SABIC Material Change

Hirose Electric Co., Ltd.
Quality Assurance Group

HRS provides representative samples

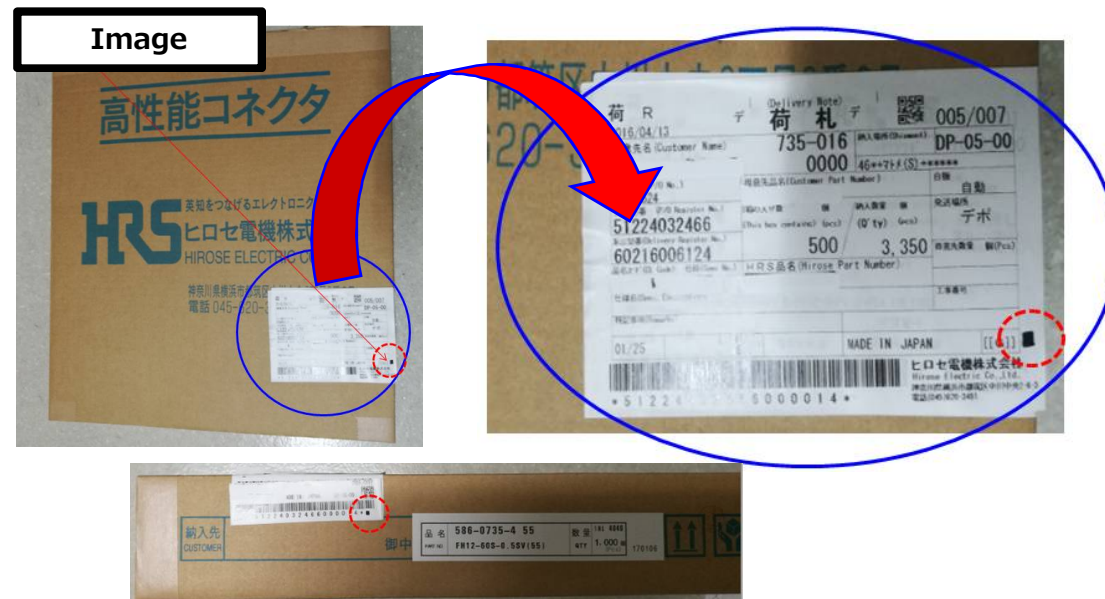
representative samples
= same type of the products HRS evaluates

Products are selected
mainly from large pin count type,
with which the evaluation results becomes severer.

1. Possible slight change for color tone

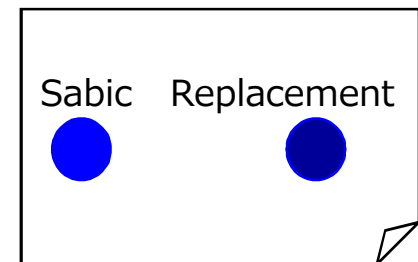
Customer's line operators
and incoming inspectors need to be notified.
HRS sales representative will provide
color sample in data file upon request.
